Date: 5/5/2017
Subject: Actuated Ball Valve Hub Design Change

Figure 1: Current Hub

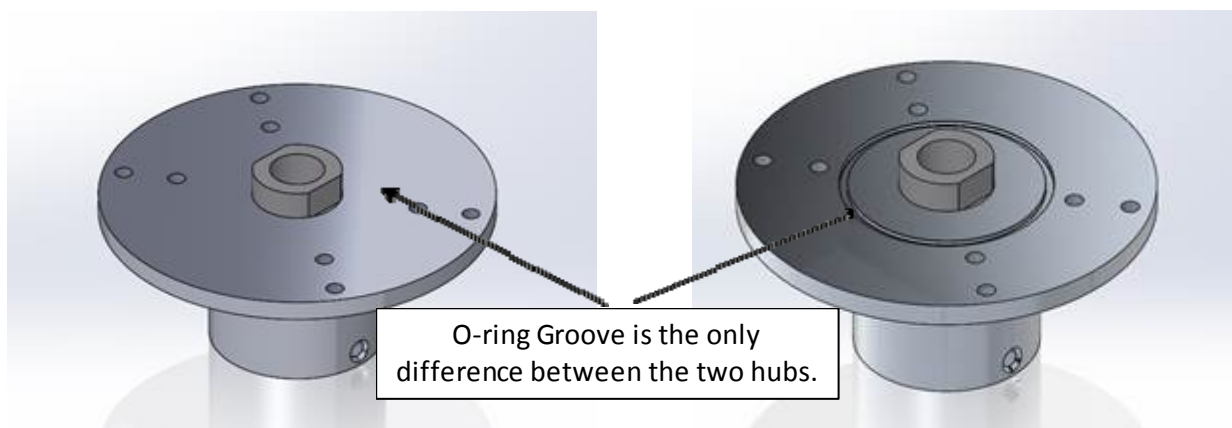
Mueller Refrigeration will implement a change to the hub component for select Actuated Ball Valve sizes. The design will be revised to include an O-ring groove on the flat surface of the hub. There will be no change in material, form or function.
